SERVICE BULLETIN

Essential information regarding engine installation, operation, and maintenance for ROTAX® 912 (Series) Aircraft Engines

ATA System: 72-00-00 Engine

Essential information regarding engine installation, operation, and maintenance for ROTAX® 912 (Series) Aircraft Engines.

Fig. 1

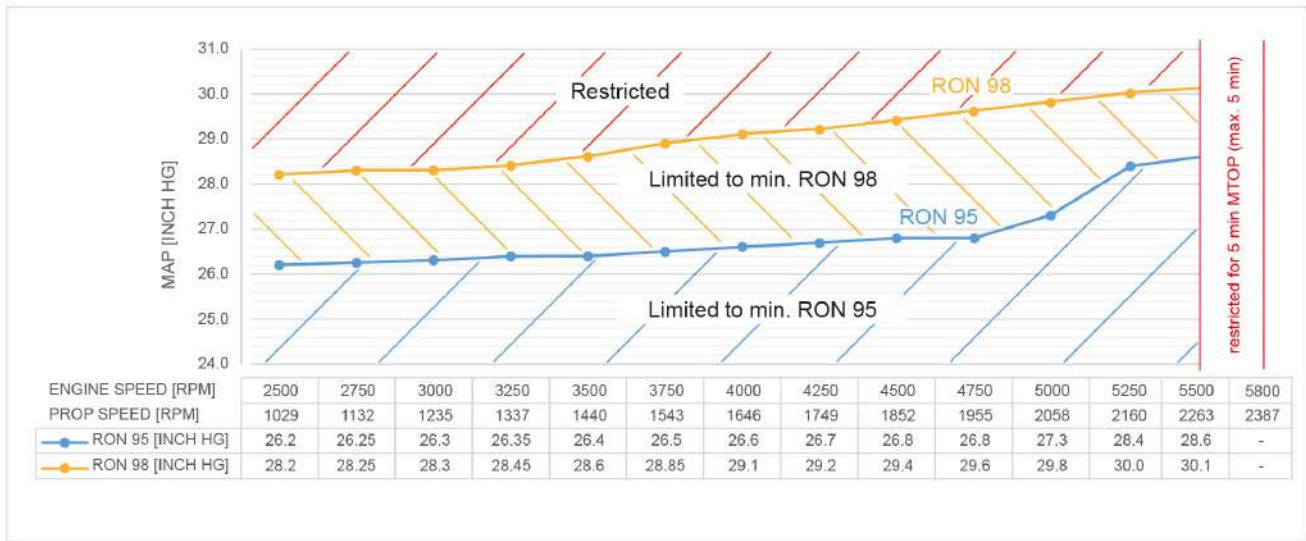
In case of an aircraft equipped with a MAP gauge by the OEM (requirement described in section 3.4.2) use the following graph to determine appropriate MAP and RPM settings depending on fuel type to ensure maximum margin/robustness for piston damage/pre-ignitions.

The area above 25.3 inch Hg must be avoided at all times when the carb. heat is on/activated.

The blue and orange lines represent the limits for RON 95 and RON 98 respectively above which piston damage may occur. The areas above the RON 95 inch Hg line and the RON 98 inch Hg line respectively must be avoided at all times. RON 95 and RON 98 lines are valid for manifold air temperature up to max. 50 °C / 122 °F. For the allowed fuels as per latest Service Instruction (SI)* the octane number of the specific fuel dictates which operating limits do apply (RON 95 or RON 98). If mixtures of different fuels are utilized, refer to the lower octane fuel as reference for selecting the operating limits.

Fig. 2
Power increase

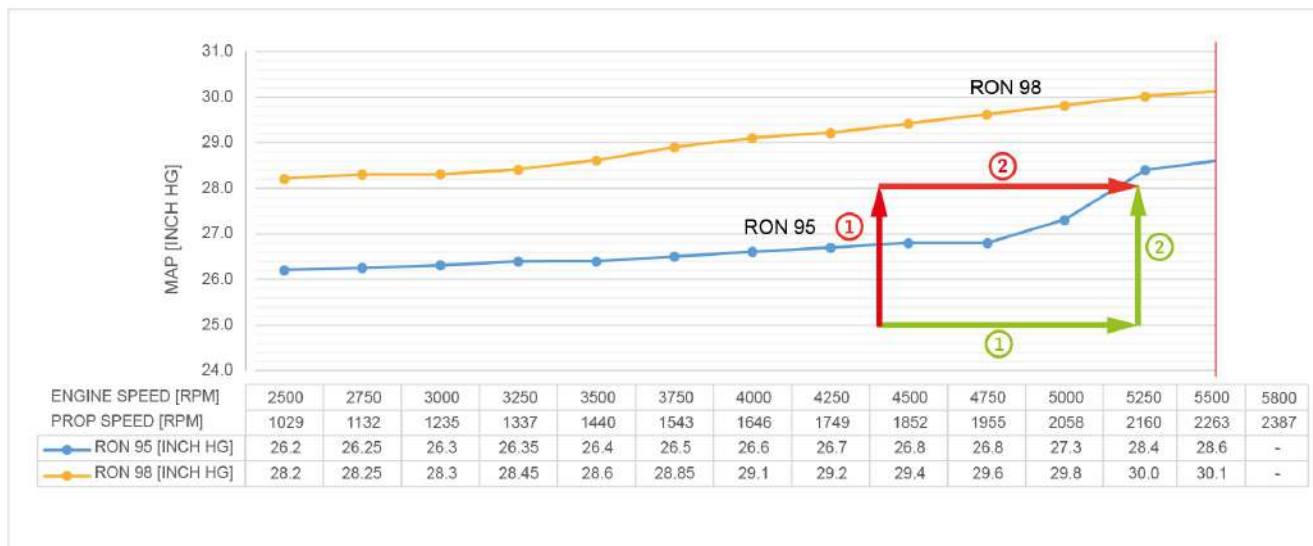
- Power increase needs to be led with the propeller control followed by the throttle control as outlined in the table below.

Step	Procedure - Power increase
1	First increase propeller speed [rpm].
2	Then increase MAP with the throttle lever.

Red arrows describe the way it should not be done. Green arrows describe the right way

Fig. 3
Power reduction

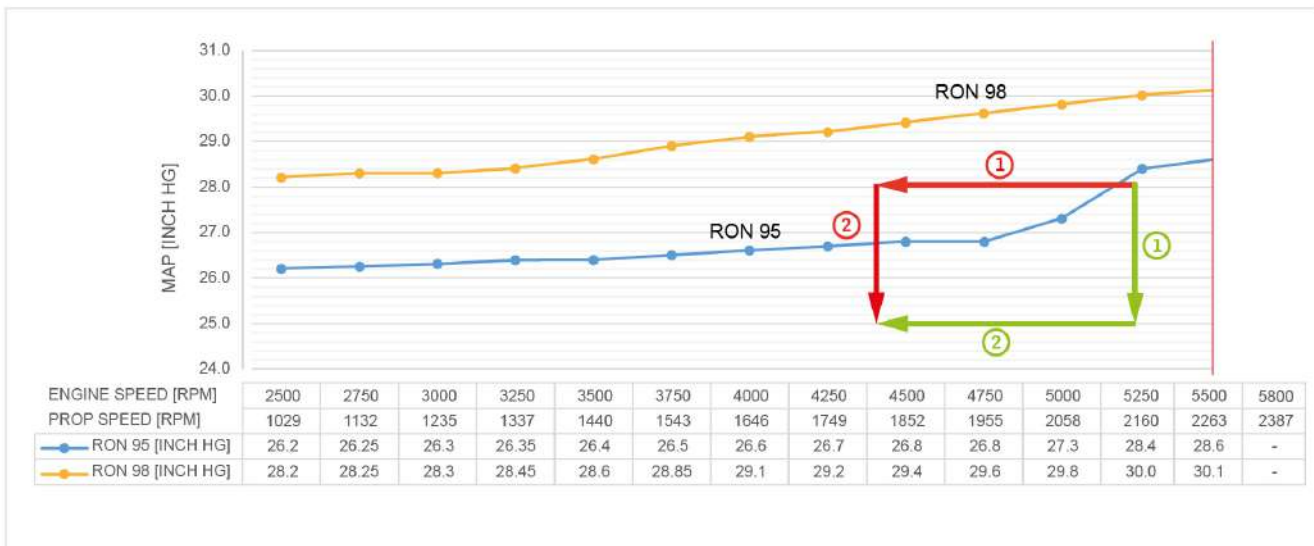
- Power reduction needs to be led with the throttle control followed by the propeller control as outlined in the table below.

Step	Procedure - Power reduction
1	First reduce MAP with the throttle.
2	Then decrease propeller speed (rpm).

Red arrows describe the way it should not be done. Green arrows describe the right way

Fig. 4

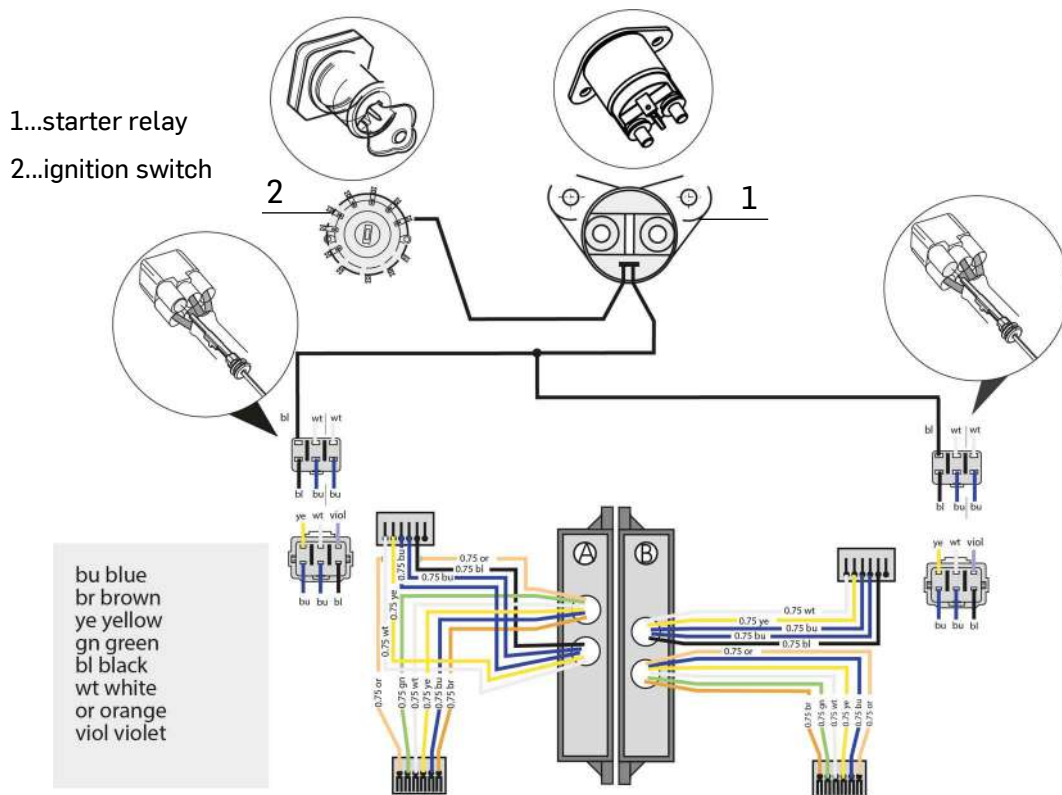
Additionally, an Advanced Start Module (ASM) System has been introduced with ignition module 966727 and later and flywheel hub 966872 and later. The Advanced Start Module System enables the optional easy-start function. In order to use the easy-start function the relevant connections to the starter relay (1) and ignition switch (2) need to be made (see fig.4).

The system is designed so that the ignition timing is automatically set to 3° after the piston's top dead center (TDC) during engine start-up between 650 to 1000 engine RPM. Consequently the ignition timing is automatically changed to 26° before the piston's top dead center above the 650 to 1000 engine RPM.

Fig. 7

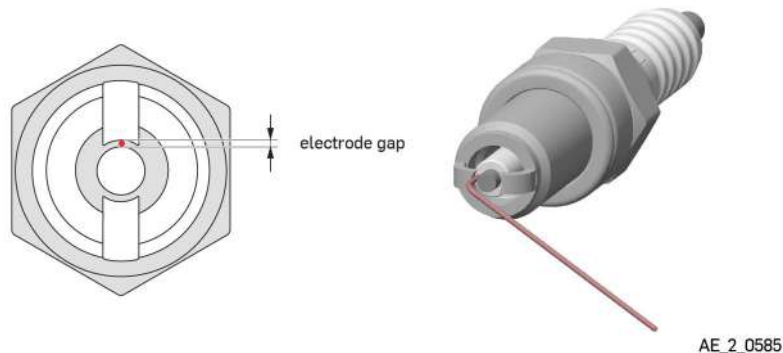
- Inspect the electrode gap as per latest Maintenance Manual Line (MML) of the respective engine type:

NOTE: Due to the curved gap between the center electrode and the ground electrodes, it is suggested to use a wire type feeler gauge for accurate gap measurement..
